SERVICE BULLETIN No.1117

COACH MODEL	: T 2100 and C2000 Series equipped with CHZ-type ADA lift, serial numbers 99-197 (year of production – unit #) or higher
BULLETIN TYPE	: Safety Recall Program NHTSA campaign number: 03V - 236
MANUAL & SECTION	: N/A
DATE	: June 30th, 2003
SUBJECT	: Wheelchair lift – frame assembly reinforcement
TERMS & CONDITIONS	: Parts and labor allowance will be provided as per Warranty Information in this Bulletin

Figure 1: Main jacking cylinder pedestal and pivot point.

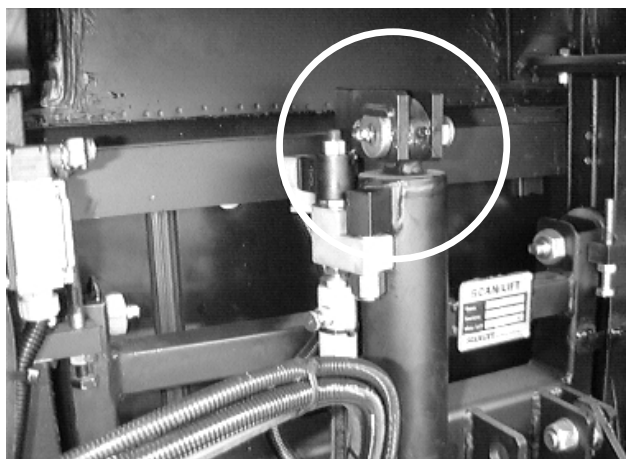
- KOS Lift, manufacturers of the CHZ-type wheelchair lift, currently installed in the above-mentioned coaches, have determined that a safety defect may exist in the lift frame assembly. In some units cracks have been found in the pedestal to which main jacking cylinder is attached (see Figure 1). These cracks may eventually lead to equipment failure, causing the platform to drop, which could result in personal injury.

- To address the issue, KOS Lift, Van Hool NV and ABC Bus Inc are running a joint campaign to reinforce the lift frame assembly.
- The affected wheelchair lifts should remain out of service for as long as the modifications, described in this Bulletin, have not been executed.

Attachment 1: Parts list:

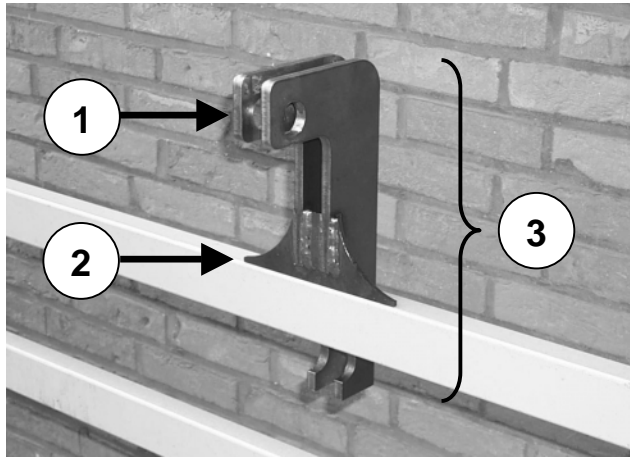
1. Main pillar section (1): 25/64 inch (10 mm)
2. Gusset section (2): 13/64 inc(5 mm)
3. Height overall: (330 mm)

Part No.	Description	Qty.
LO311401	Top pedestal for main jacking cylinder, modified	1

Figure 2

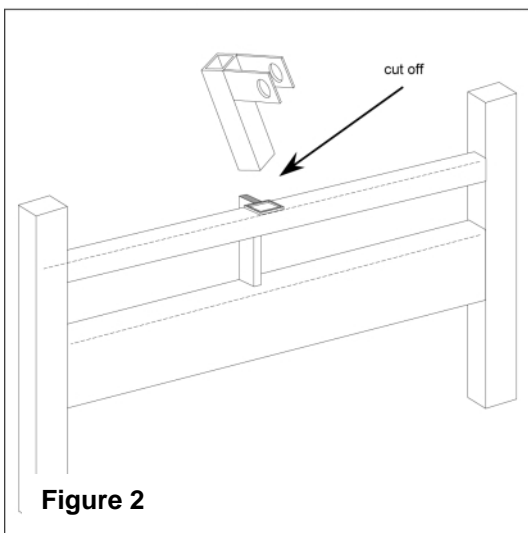
- Disconnect the positive battery cable.
- Remove the hydraulic hose clamp nearest to the cylinder.
- Remove the hose rupture valve from the cylinder.
- Remove the 2 pivot joints that connect the vertical cylinder to the lift frame.
- Move the cylinder sideways.
- Cover the area around the pedestal with a welding blanket. Pay attention to covering the hydraulic connections.
- Cut off the pedestal made of 1-37/64 x 1-37/64 inch (40 x 40mm) tube and 1-3/16 x 25/64 inch (30 x 10mm) strip. Cut just above the joint to the horizontal 40x40mm tube. A stump of maximum 3/64 inch (1 mm) should remain, (see Figure 2).

Figure 3

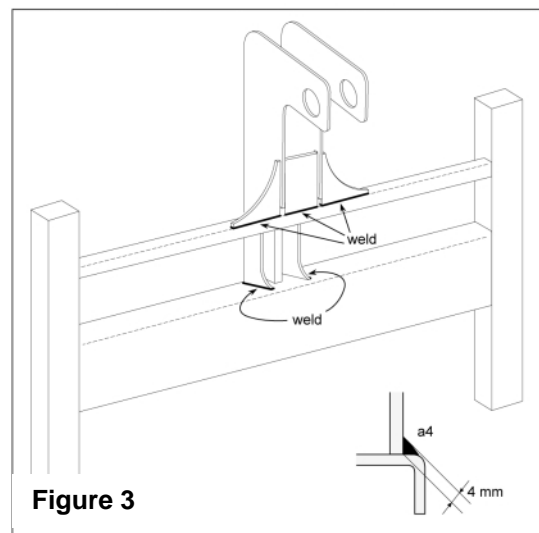
- Make the area around the stump free of paint.
- Make the area around the 1-3/16 x 25/64 inch (30 x 10mm) strip welded onto the mainframe 6 x 3 inch (150 x 75mm tube), free of paint.
- Place the modified pedestal in position as indicated in Figure 3.
- Weld as indicated in Figure 3.
- Apply conservative paint to the welded parts and the modification part.
- Reinstall the telescopic cylinder (pivot joints 192 ft.lbf - 260 Nm, hose rupture valve 37 ft.lbf - 50 Nm).
- Connect positive battery cable.
- Connect negative battery cable.
- Go through several complete lift cycles to de-air the hydraulic system.
- Check functioning of lift.
